2 Type of change

Modification of approval marks.
Slight modification on the lateral indentation.

| 4752 Strip Block | | | | | 0118.2240 | |

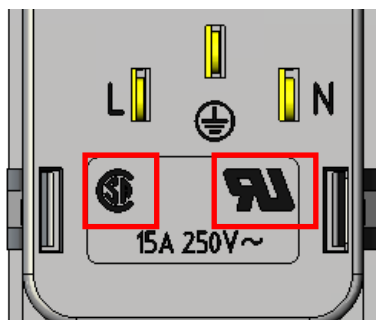
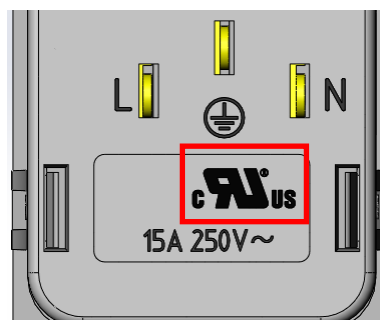
New combined cURus approval mark instead of separate UR and CSA marks.
Slight modification on the lateral indentation.

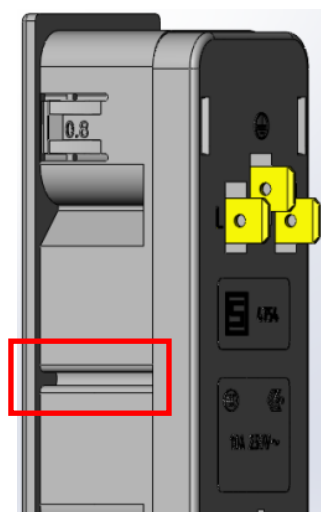
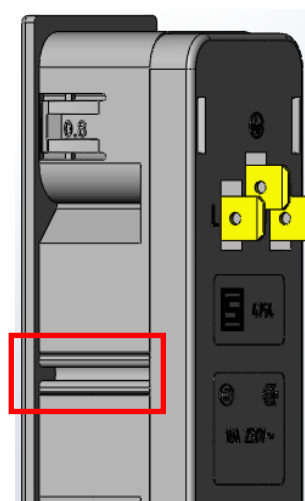
Consolidation of North American approval marks with the combined cURus mark.
Slight modification on the lateral indentation because of optimization of the injection process.

Form: Yes Slight modification on the lateral indentation.
Fit: No There are no dimensional changes.
Function: No No change on the specification.
Production Site: No There is no change of the production site.
Product Label: Yes CSA and UR marks replaced by cURus mark.
